UNITED STATES
DEPARTMENT OF THE INTERIOR
BUREAU OF LAND MANAGEMENTFORM APPROVED
OMB NO. 1004-0135
Expires: July 31, 2010**SUNDRY NOTICES AND REPORTS ON WELLS**
*Do not use this form for proposals to drill or to re-enter an abandoned well. Use form 3160-3 (APD) for such proposals.*5. Lease Serial No.
NMNM0925 **NM 54183**

SOUTH LOCO HILLS UNIT 7

30-015-03521

OXY USA Inc. - Proposed
South Loco Hills Unit #7
API No. 30-015-03521

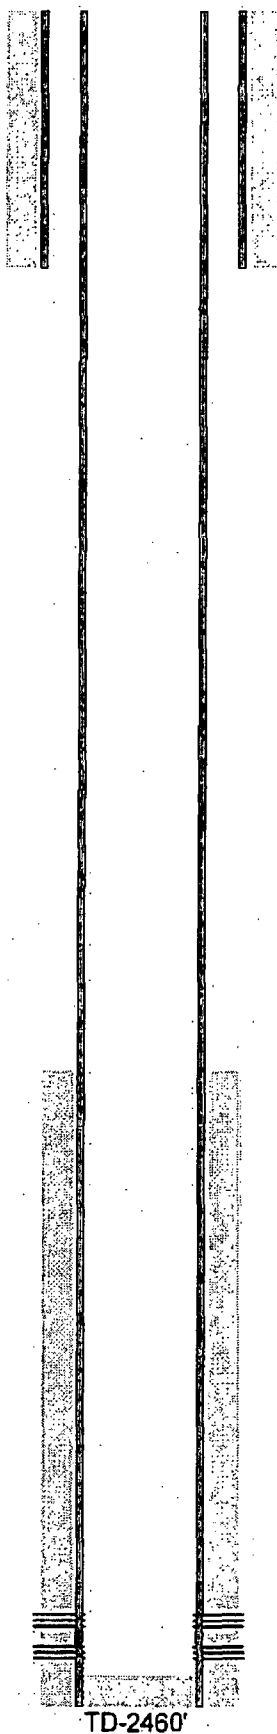
1. RIH & set CIBP @ 2335', M&P 60sx cmt to 1925' WOC-Tag
2. Perf @ 1350' sqz 40sx cmt to 1235' WOC-Tag
3. Perf @ ~~800'~~ sqz 35sx cmt to 690' WOC-Tag **900'**
4. Perf @ 450', sqz 150sx cmt to surface

11" hole @ 400'
8-5/8" csg @ 400' ✓
w/ 150sx-TOC-Surf-Calc

35sx @ 800-690' WOC-Tag

Perf @ 800'
